MIL-C-39029/103A
AMENDMENT 1
21 June 1999

MILITARY SPECIFICATION SHEET

CONTACTS, ELECTRICAL, CONNECTOR, SOCKET, CRIMP REMOVABLE, COAXIAL, SIZE 12, (FOR MIL-C-38999 SERIES I, II, III AND IV CONNECTORS)

This amendment forms a part of MIL-C-339029/103, dated 31 March 1988, and is approved for use by all Departments and Agencies of the Department of Defense.

Figure 1, replace the “INNER PIN CONTACT (CRIMP)” detail drawing, with the following:

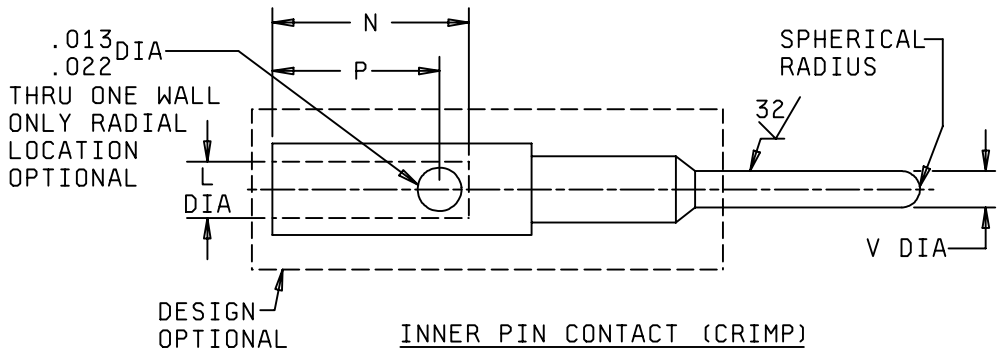
Delete the following dimensions from the table: M, R, S, T, U and W.

Replace the N dimension with “ N: .084 min, .100 max ”.
Replace the P dimension with “ P: .063 min, .088 max ”.

Figure 2. Vibration envelope.

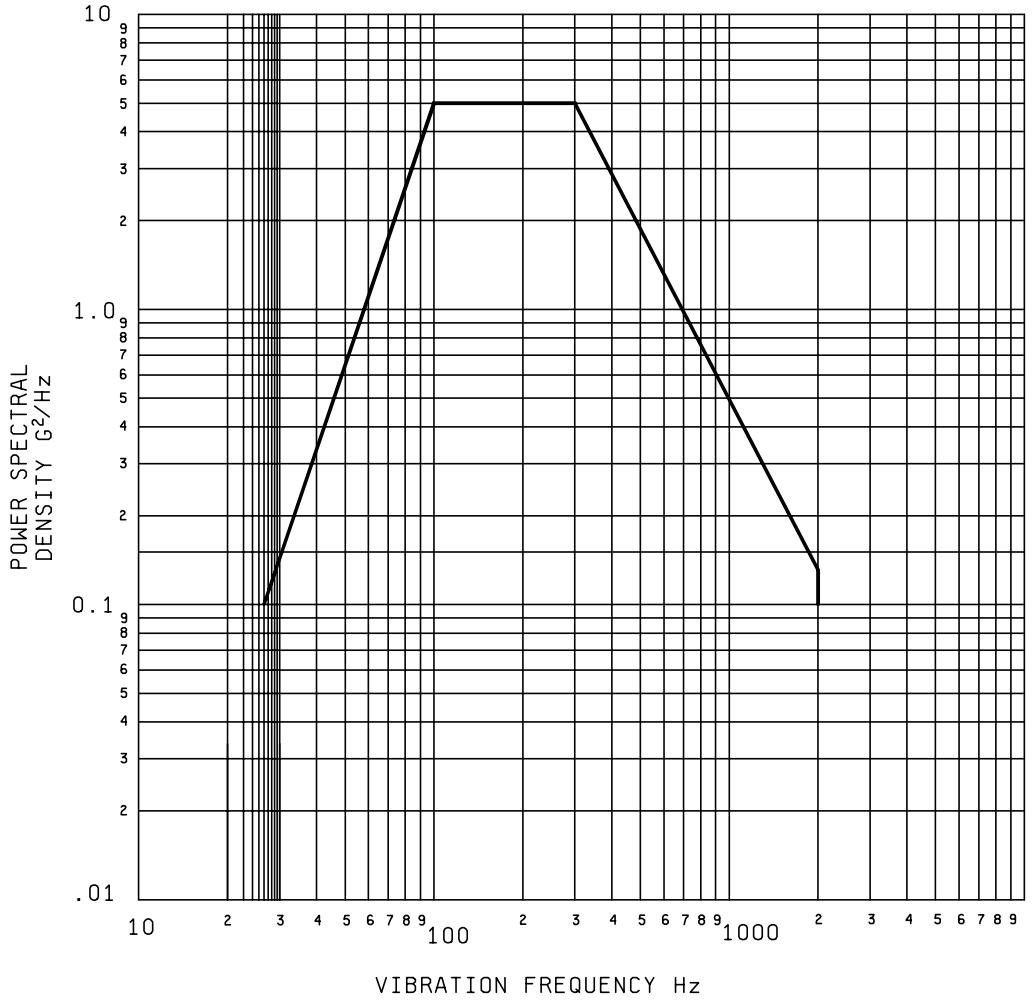
Delete subparagraph a, and substitute the following:
" a. Test condition V. Use the vibration envelope shown on figure 2 herein".
